1 **Annex N**

5 **C-Port in Port Mode using the TKP Access Protocol**

Details of Annex N Changes

This section identifies the reason for the annex N changes per Ballot Comment KTW16.

Figure N-1 Transmit FSM (TS=State): C-Port in Port Mode using the TKP Access Protocol

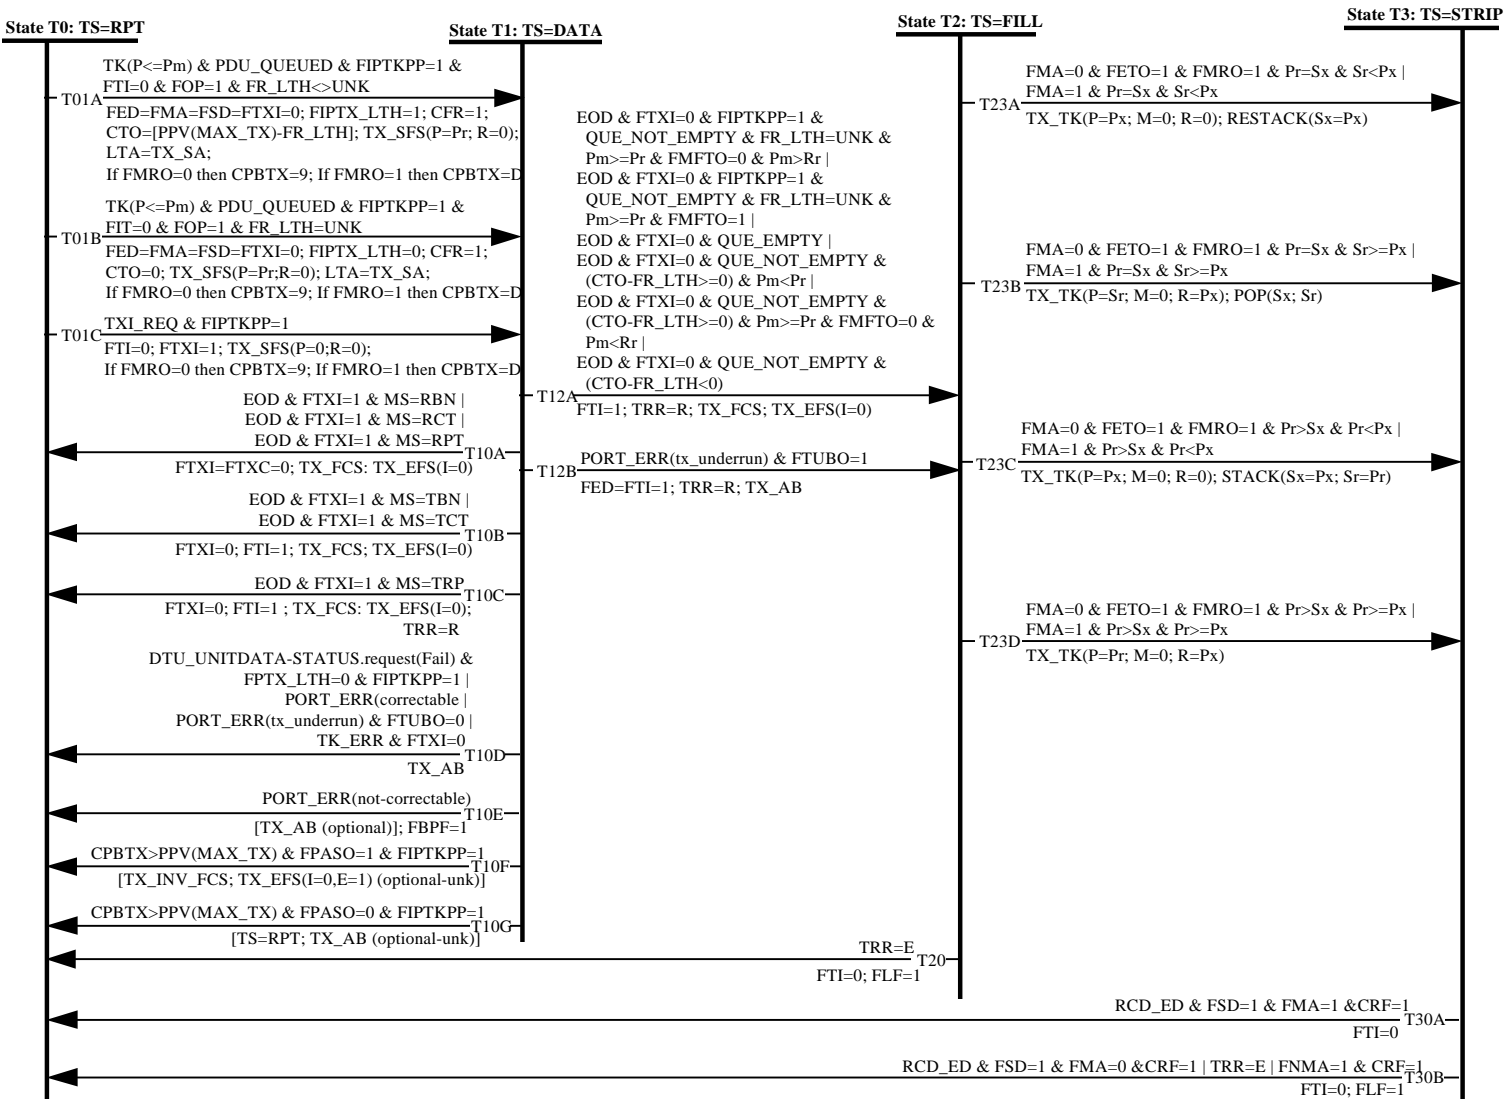
A) Figure N-1 page N-2 Transmit FSM has been changed as follows.

1) Transition T01B event: The term "TS=RPT" has been removed since it is redundant.

2) Transition T12A action: The term "TRR=E" is incorrect and has been replaced by "TRR=R".

3) Transition T12B action: The term "TRR=E" is incorrect and has been replaced by "TRR=R".

4) Transition T23D event: The term "Pr=Sx & Sr<Px" is incorrect and has been replaced with "Pr>Sx & Pr>=Px".

Figure N-2 Monitor FSM (MS=State): C-Port in Port Mode using the TKP Access Protocol

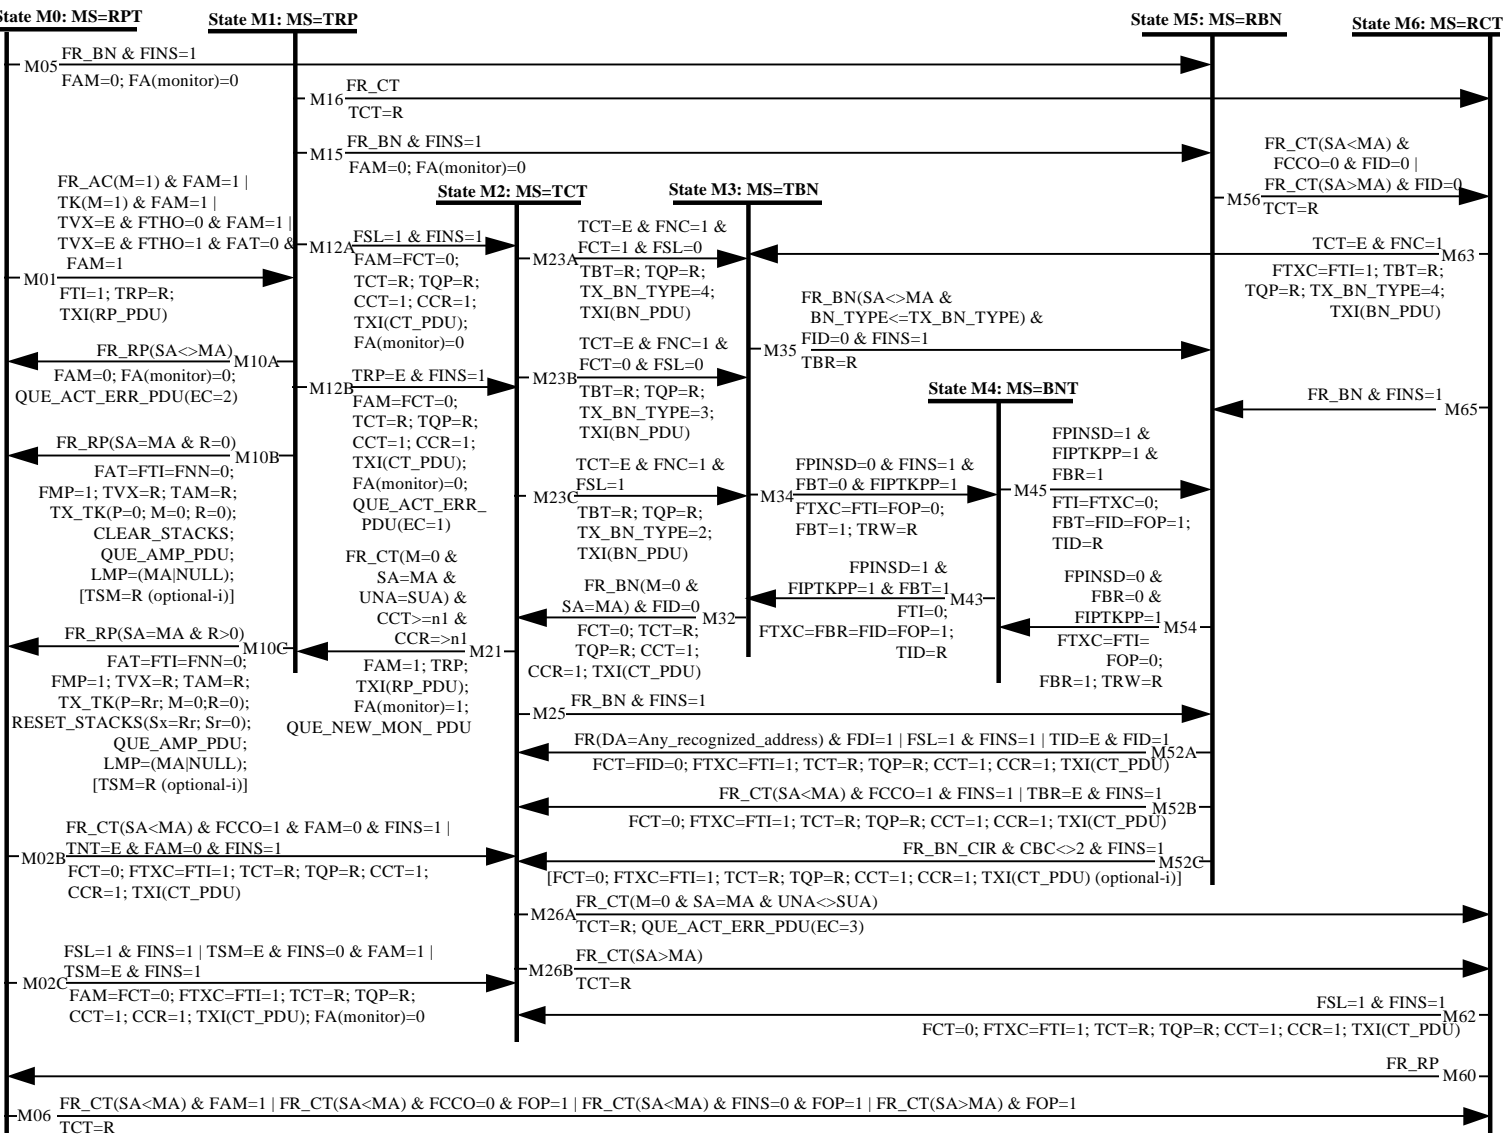
B) Figure N-2 page N-3 Monitor FSM has been changed as follows.

1) Transition M10B has been changed to M10A to agree with 802.5s and 9.4.

2) Transition M10A has been changed to M10B to agree with 802.5s and 9.4.

3) The changes in 1) and 2) causes the position of the original Transitions to be reversed.

4) Transition M02A has been deleted since it is not part of 9.4 and is in annex S as a deletion.

5) Transition M06 event: The term "FR_CT(SA=MA) & FAM=1" is incorrect and has been replaced by "FR_CT(SA<MA) & FAM=1".

6) Transition M54 is missing and has been added per 9.4 as follows

a) The M54 event is as follows.

CBR=0 & FDR=0 & FIPTKPS=1

b) The M54 action is as follows.

FBR=FTW=1

7) Transition M65 event: The term "FNC=1" is incorrect and has been replaced by "FINS=1".
